RE: 56 MGD Upgrade Project T.Z. Osborne – Package 2
Effluent Filter – Effluent Facilities

As a follow up to various onsite meetings and discussions, Garney offers the following quotation for the construction of the Chlorine Contact Splitter Box, Filter Effluent Structure, and interconnecting piping.

SIZE	FSCM NO.	DWG NO.	REV
SCALE NTS		TZ03-E

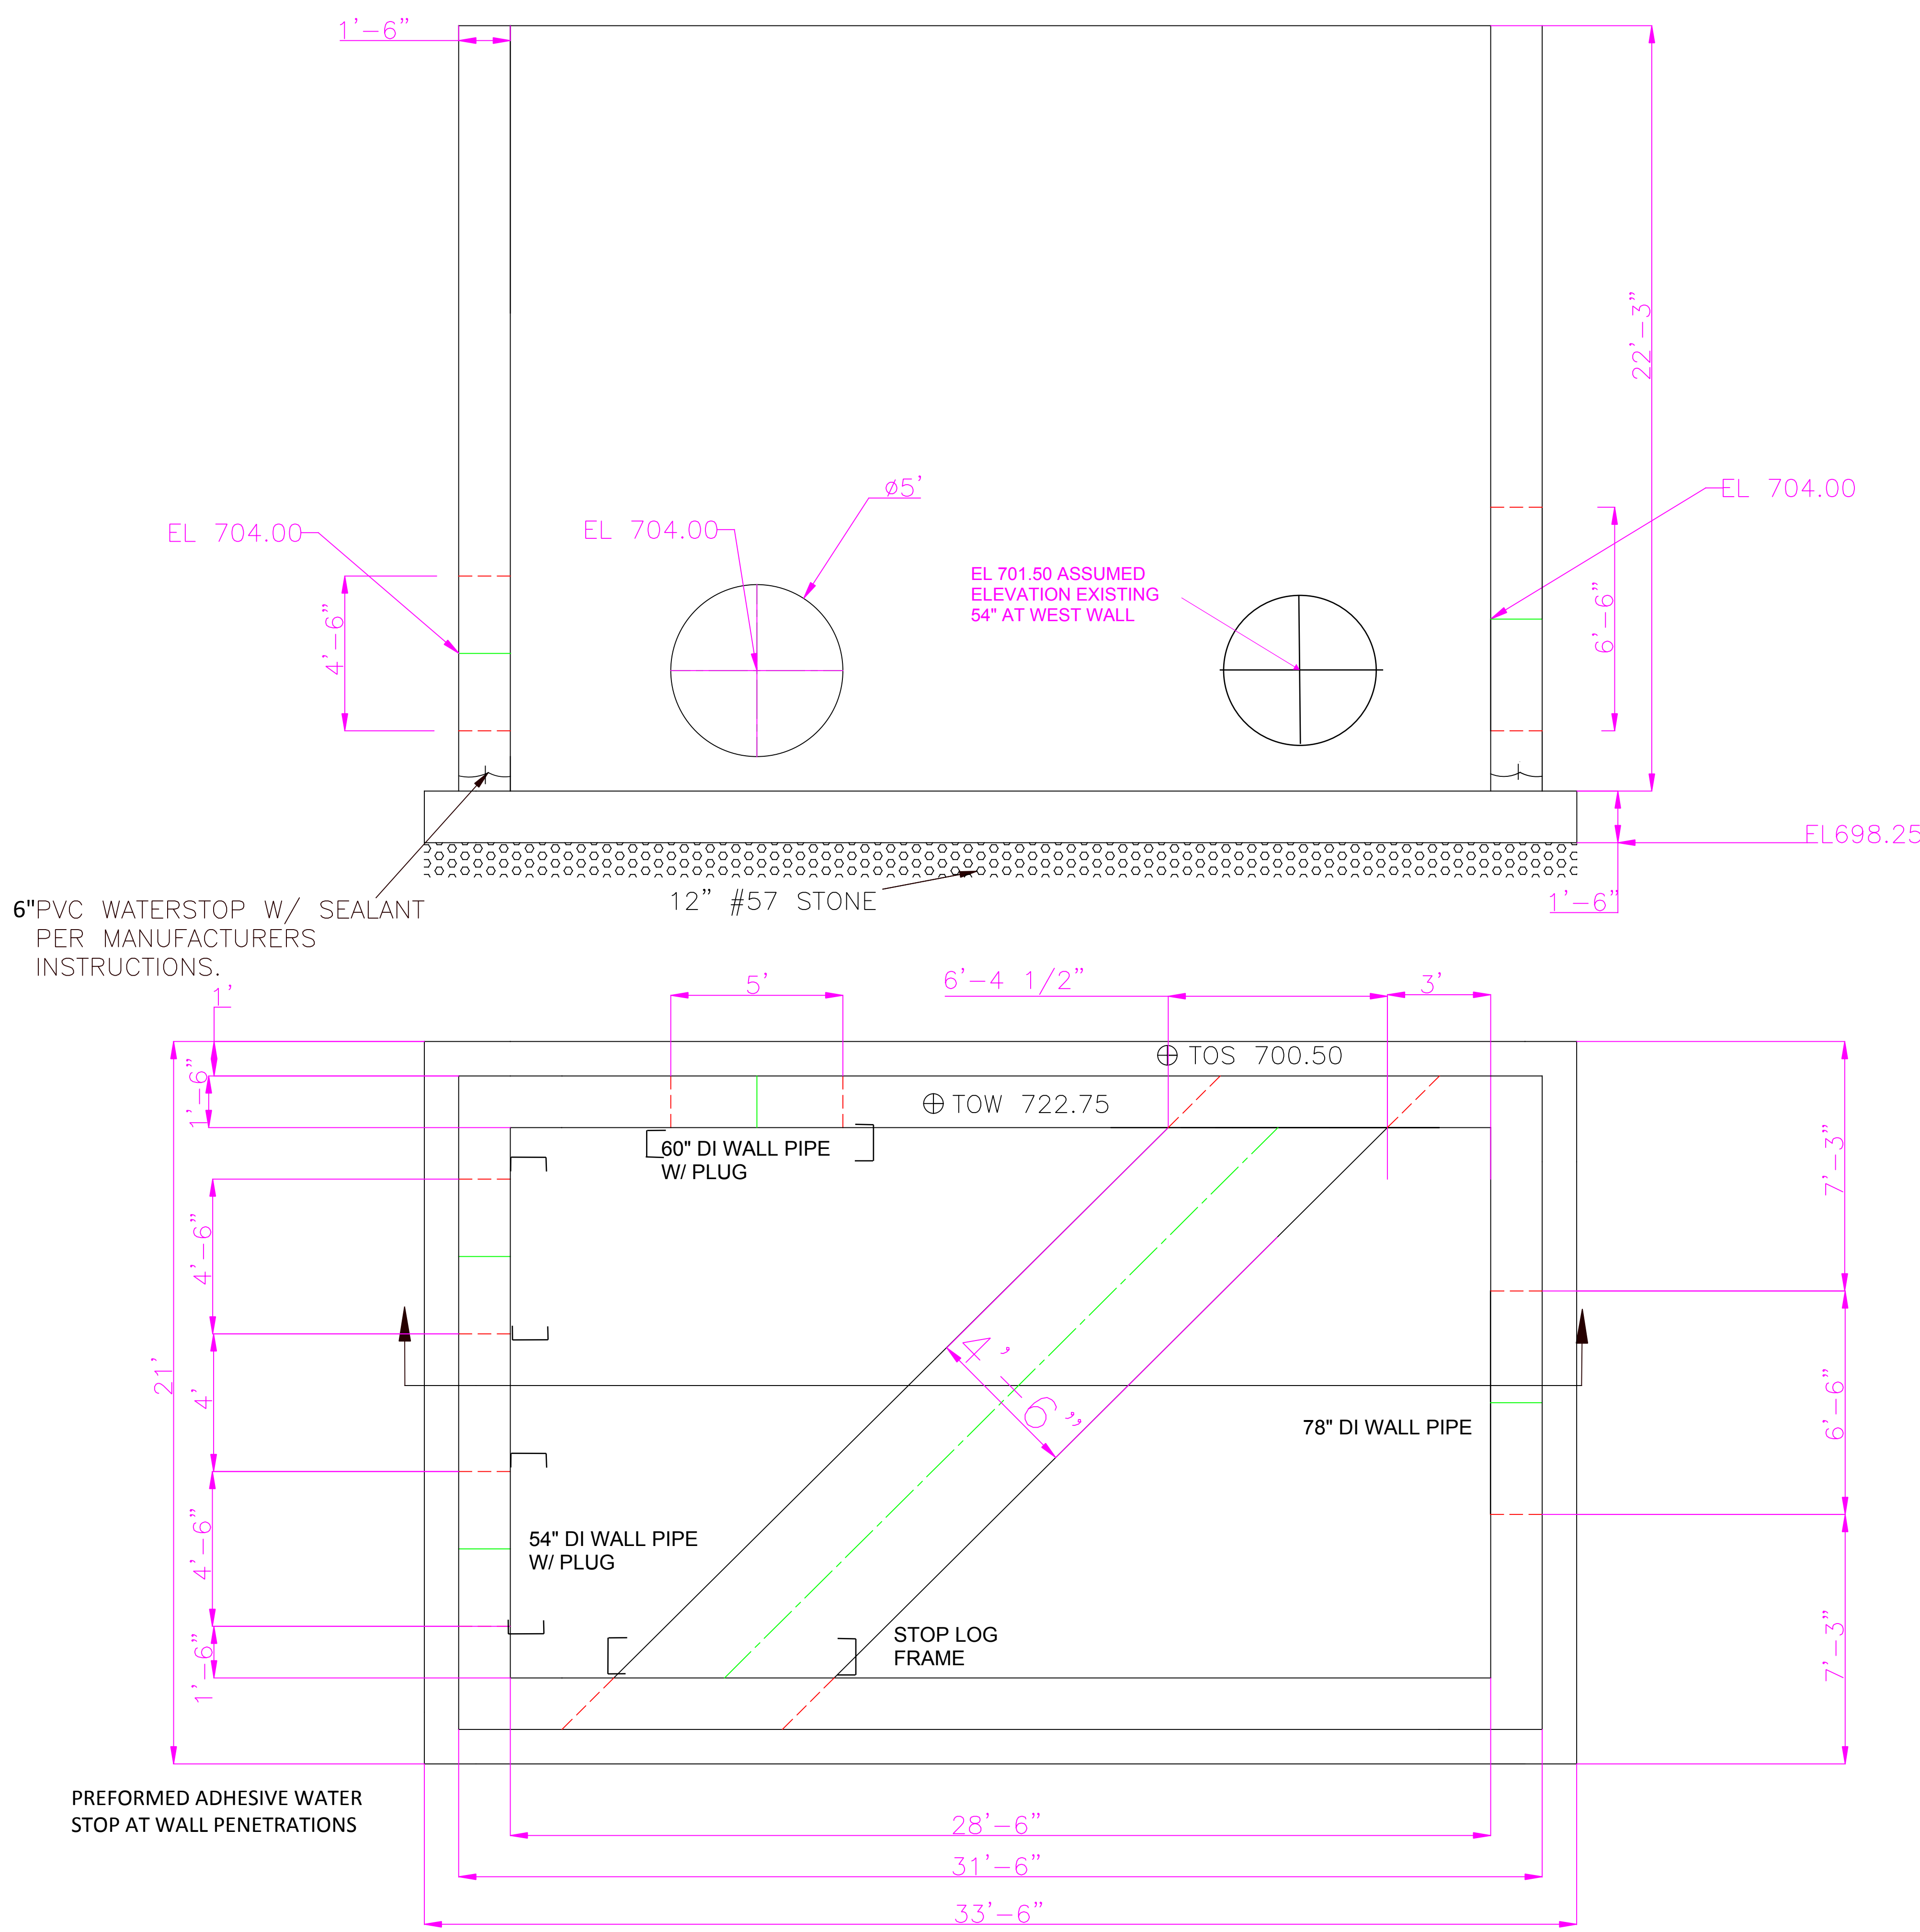
5. Chlorine Contact Splitter Box
 - a. Size, shape and elevations as indicated on attached sketch titled TZO3-E, dated October 19, 2015
 - b. 15 Tons of reinforcing steel

- c. Walls no more than 18-inches thick
 - d. Slabs no more than 18-inches thick
 - e. One 78-inch wall PCCP wall pipe connection to Filter Effluent Pipeline, at Elevation 704.0 FT

- f. One restrained joint 54-inch ductile iron wall pipe with plug, for connection by Contract 3 to New Chlorine Contact Tanks 5 & 6. Wall pipes shall be furnished using either the US Pipe or ACIPCO restraint system.

- g. 60-inch and 54-inch wall pipes with plugs for future connection. Wall pipes shall be furnished using either the US Pipe or ACIPCO restraint system.

- h. 12-inches of crushed concrete / stone base below slab
 - i. Galvanized steel stop log frames at each wall pipe within the Chlorine Contact Splitter Box. Frames shall be set to receive the 5-foot logs, furnished under Contract 3.

10/19/2015	SIZE	FSCM NO.	FIG NO.	TZ03-F	REV
P. TETEN	SCALE NTS		SHEET

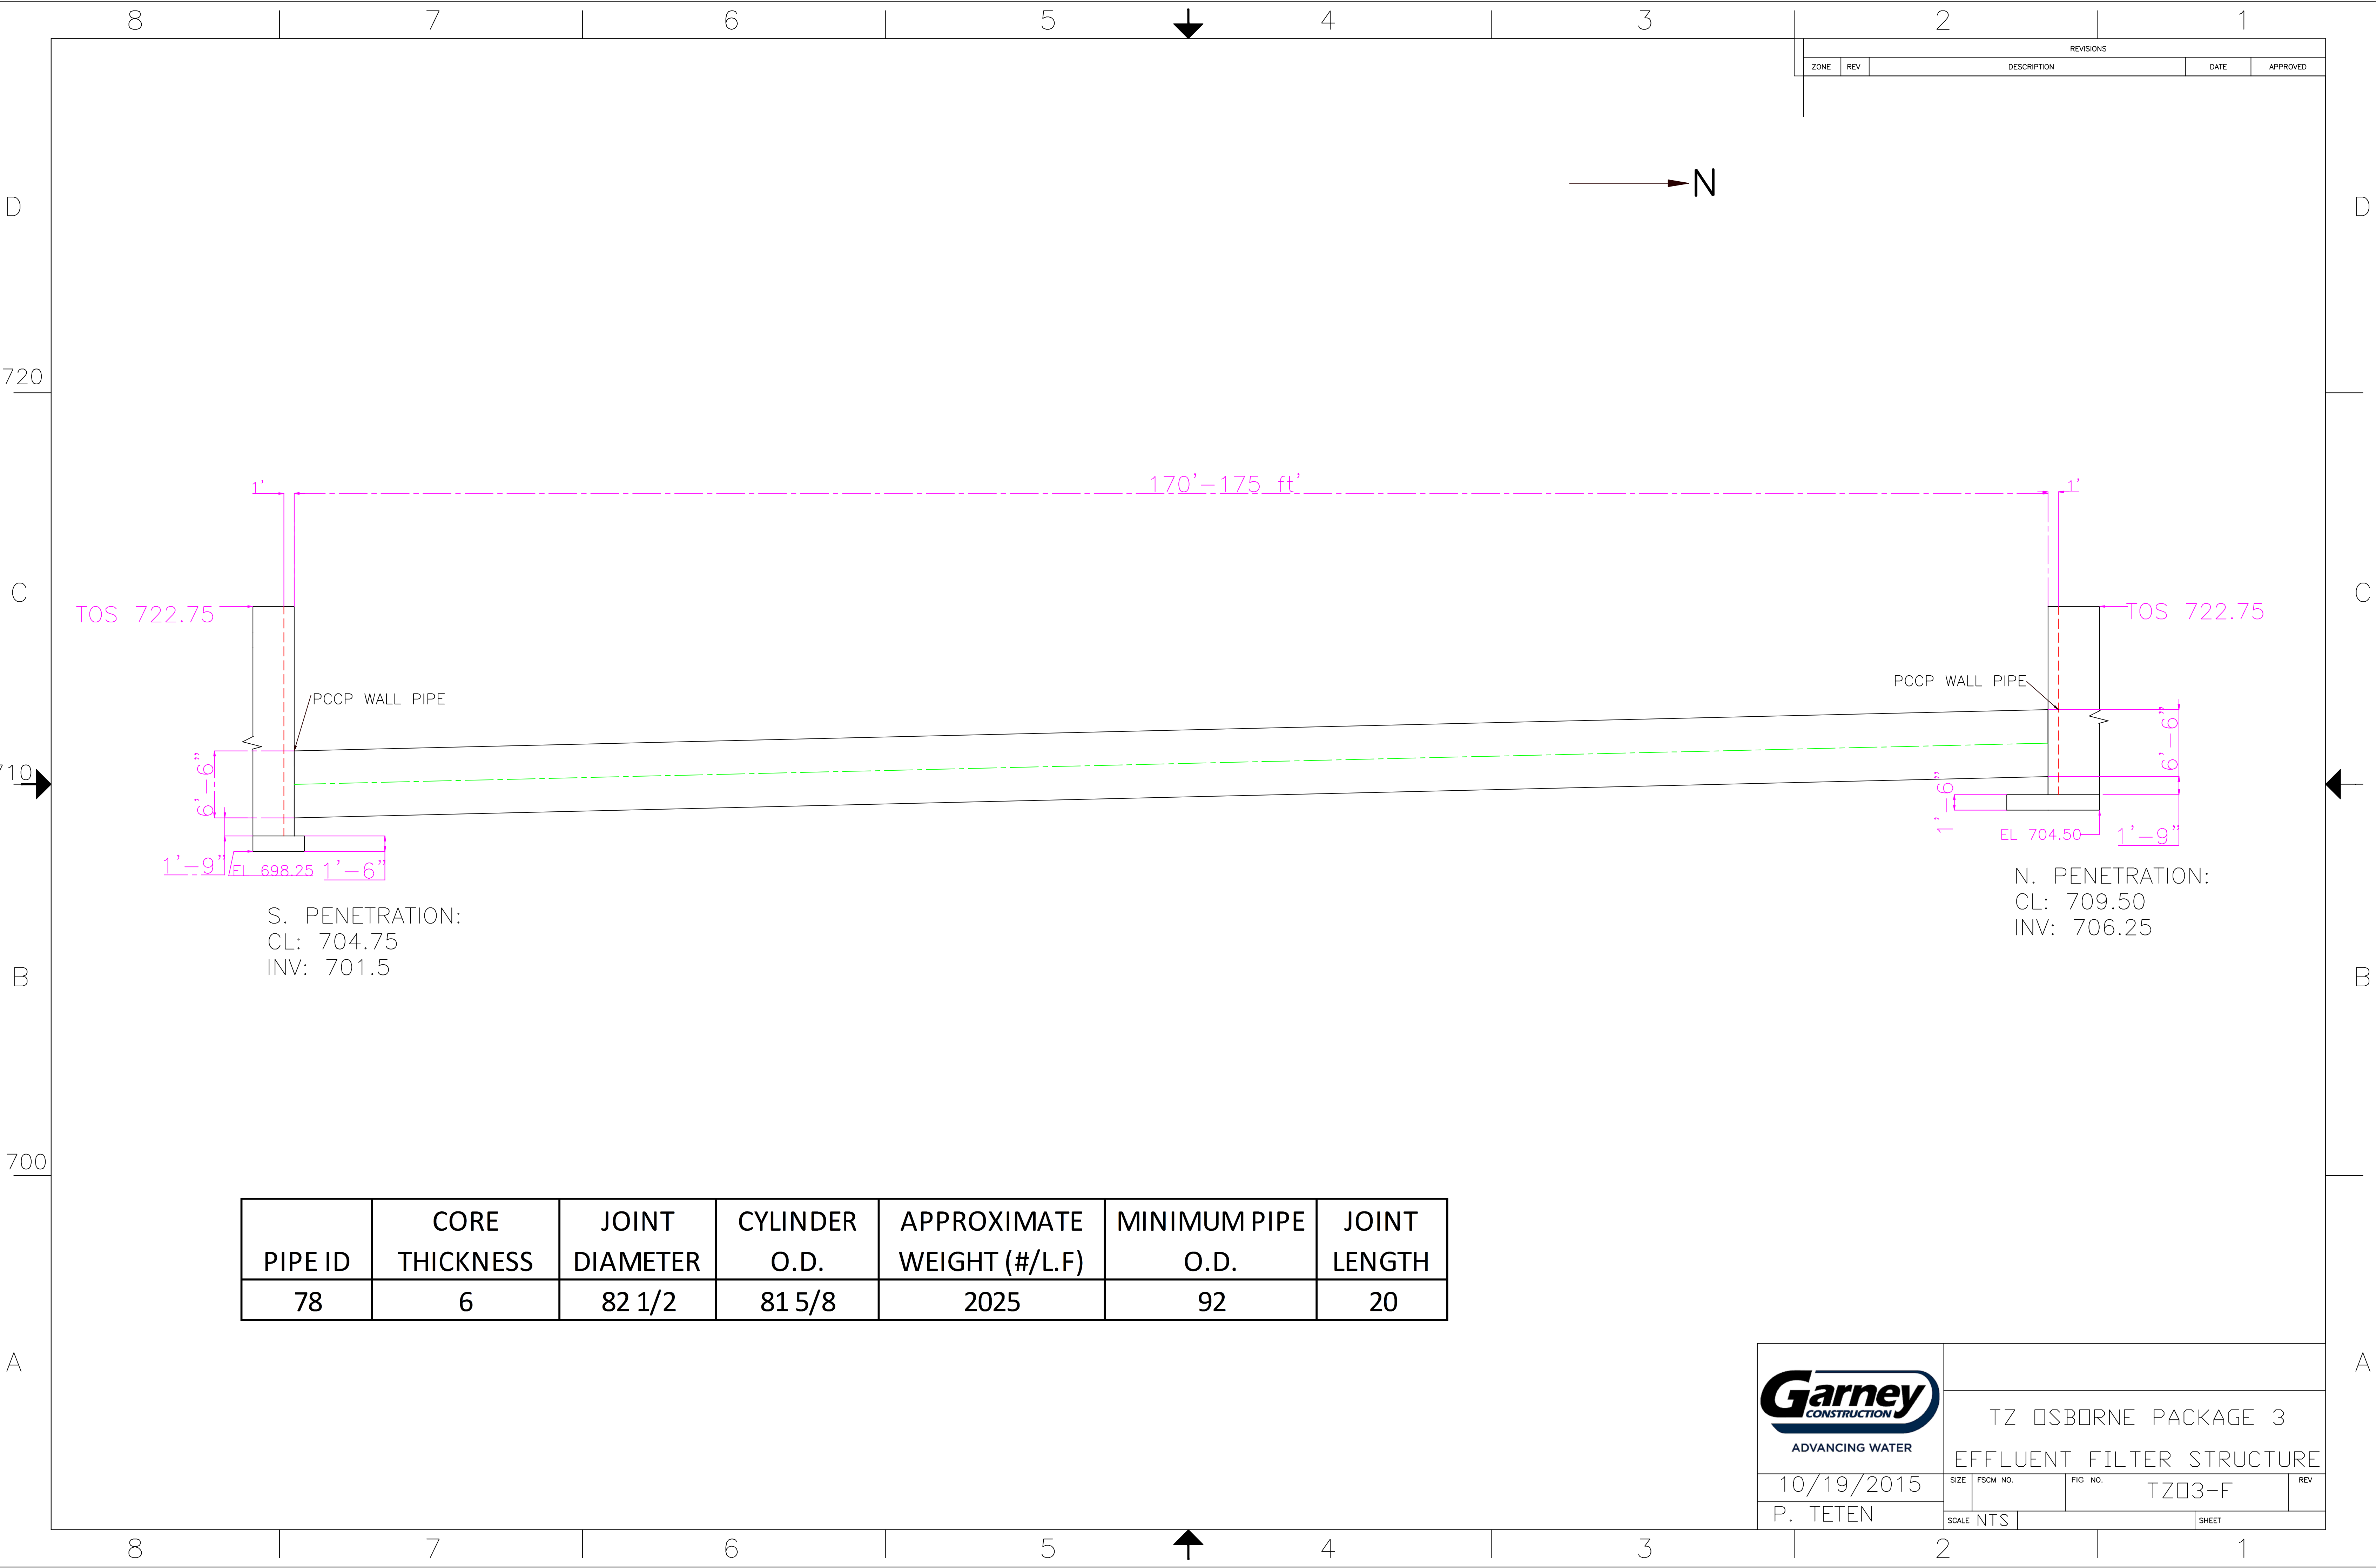
6. Filter Effluent Pipeline
- a. Layout, elevation and alignment as shown on attached sketch titled TZO3-F, dated October 20, 2016
 - b. 78-inch pre-stressed concrete cylinder pipe (PCCP) filter effluent pipe interconnecting Filter Effluent Structure and Chlorine Contact Splitter Box

- c. 175 liner feet 78-inch PCCP, with wall pipes at either end.
 - d. #57 stone bedding, 6-inches thick below pipe, and to pipe centerline. Backfill with soil above.
